# UNITED STATES PATENT AND TRADEMARK OFFICE

APPLICATION NO.	FILING DATE	FIRST NAMED INVENTOR	ATTORNEY DOCKET NO.	CONFIRMATION NO.
10/533,663	05/03/2005	Naohide Wakita	10873.1677USWO	6214
53148 7590 12/19/2006 HAMRE, SCHUMANN, MUELLER & LARSON P.C. P.O. BOX 2902-0902 MINNEAPOLIS, MN 55402			EXAMINER ROJAS, OMAR R	
			ART UNIT 2874	PAPER NUMBER

**Office Action Summary**

## **DETAILED ACTION**

**FIG. 1a****FIG. 1b**

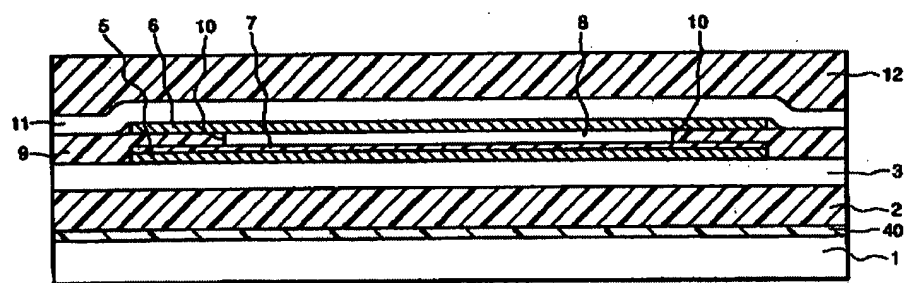
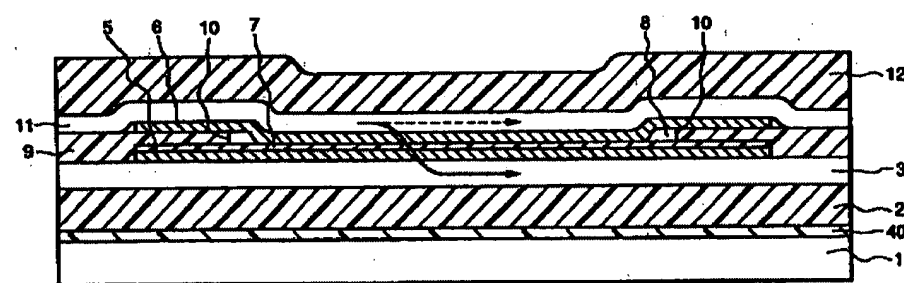
*In re* claim 1, Ghezzi discloses a display element (e.g., see Figures 1a-1b) comprising a light source for providing light and a waveguide that comprises a deformable core 11 that propagates a light emitted from the light source, wherein the light propagated in the waveguide is extracted to outside from a waveguide lateral face,

the display element further comprising a plurality of actuators 5/6/7 that deform a shape of the waveguide,

wherein the actuators 5/6/7 are operated selectively to deform a surface shape of at least a portion of the core 11 on the waveguide lateral face to a concavo-convex shape so as to change a reflection direction of light propagated in the waveguide thereby *inherently* extracting light out of the display element from the waveguide lateral face. Figures 1a-1b of Ghezzi are reproduced below.

*In re* claim 3, the waveguide comprises a cladding 8/9 formed along one lateral face of the core 31, wherein the actuators 5/6/7 are attached to the cladding 8/9 and the shape of the waveguide lateral face is changed by deforming the actuators.

*In re* claims 11-12, the waveguide core 11 is elastic and deforms to extract light out of the waveguide as seen in Figures 1a-1b.

Fig. 1

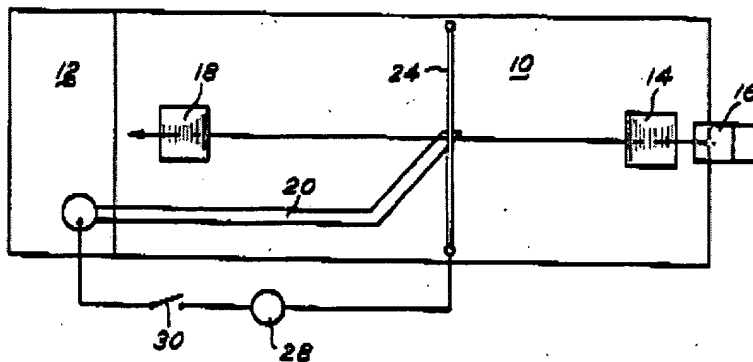
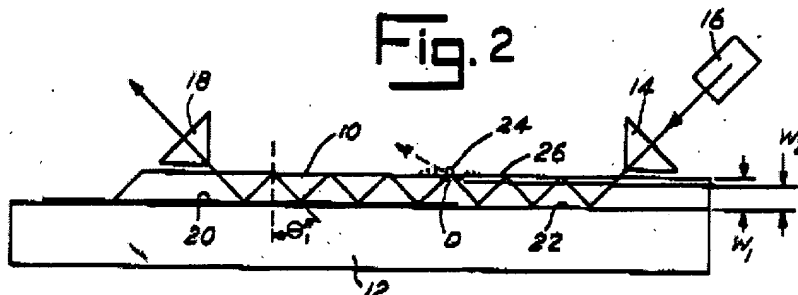
*In re* claim 1, Conwell discloses a display element (e.g., see Figures 1-2) comprising a light source 16 for providing light and a waveguide that comprises a deformable core 10 that propagates a light emitted from the light source 16, wherein the light propagated in the waveguide is extracted to outside from a waveguide lateral face 26,

the display element further comprising a plurality of actuators 20/24 that deform a shape of the waveguide,

wherein the actuators 20/24 are operated selectively to deform a surface shape of at least a portion of the core 10 on the waveguide lateral face to a concavo-convex shape so as to change a reflection direction of light propagated in the waveguide thereby extracting light out of the display element from the waveguide lateral face as seen in Fig. 2. Figures 1-2 of Conwell are

In re claims 8-12, the actuators 20/24 comprise a round electrode film/filament 24 arranged at the waveguide lateral face and comprising a convex portion; and

an external electrode film 20 in opposition to and adjacent to the waveguide

wherein the shape of the waveguide lateral face 26 is changed by an electrostatic force between the films 20 and 24 and pressure to the waveguide lateral face with the convex portion is made by using the electrostatic force;

and the pressure causes the waveguide core 10 to deform and the core is an elastomer (see columns 2-3).
